From: Rael, Rudy E.
Sent: Thursday, September 29, 2016 1:34 PM
To: 'David Soule (david@riograndeengineering.com)'
Subject: Luna Residence SAD 227

Based upon the information provided in your submittal received 9/13/16, the above referenced Grading and Drainage plan dated 9/9/16 cannot be approved for Grading Permit or Building Permit until the following comments are addressed:

LOT 7, BLOCK 11 UNIT 5 VOLCANO CLIFFS SUBDIVISION	DRAWN BY JDG
	GRADING AND DRAINAGE PLAN	DATE 09-11-2016
	1606 CENTRAL AVENUE SE SUITE 201 ALBUQUERQUE, NM 87106 (505) 872-0999	SHEET # 1 OF 1
		JOB #

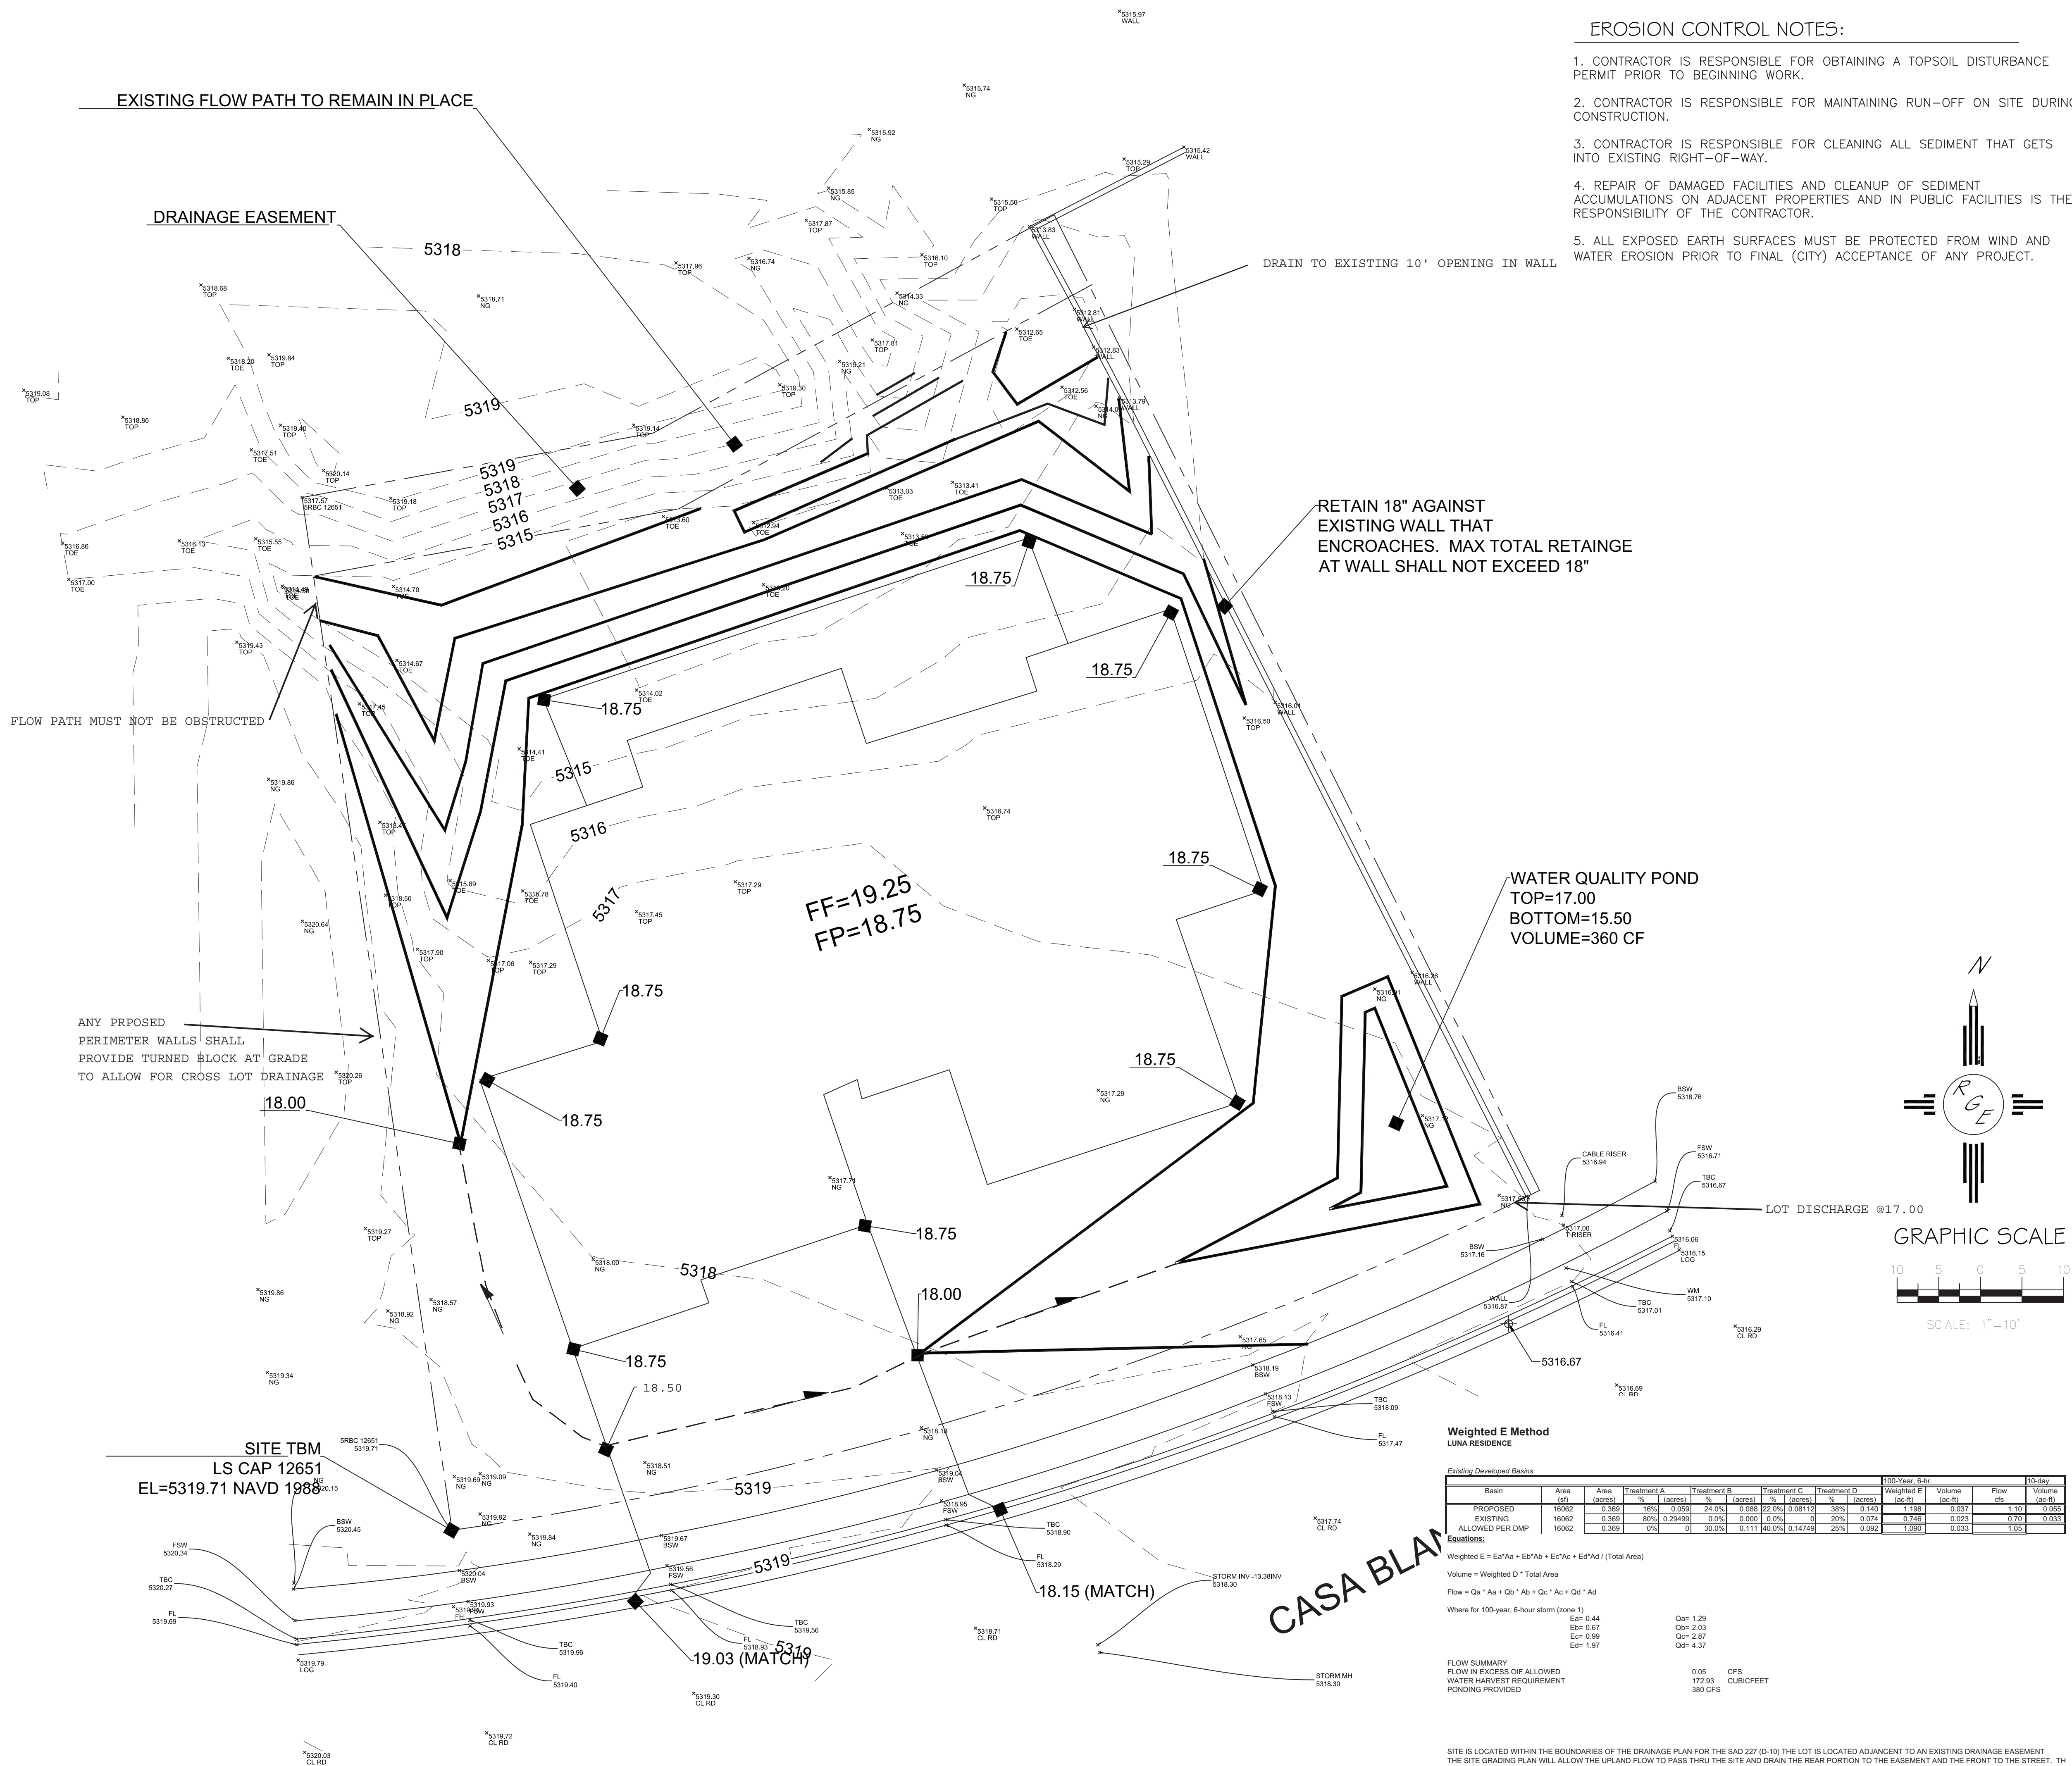
- Enlarge the drainage calcs or provide on a separate sheet with the proper font size. Once submitted the calculations will be checked.
- Add a note stating that a Pad Certification will be required before the pouring of the concrete pad and that all work will be stopped until hydrology has approved the pad elevation. Also add that an inspection for CO from hydrology is a requirement.
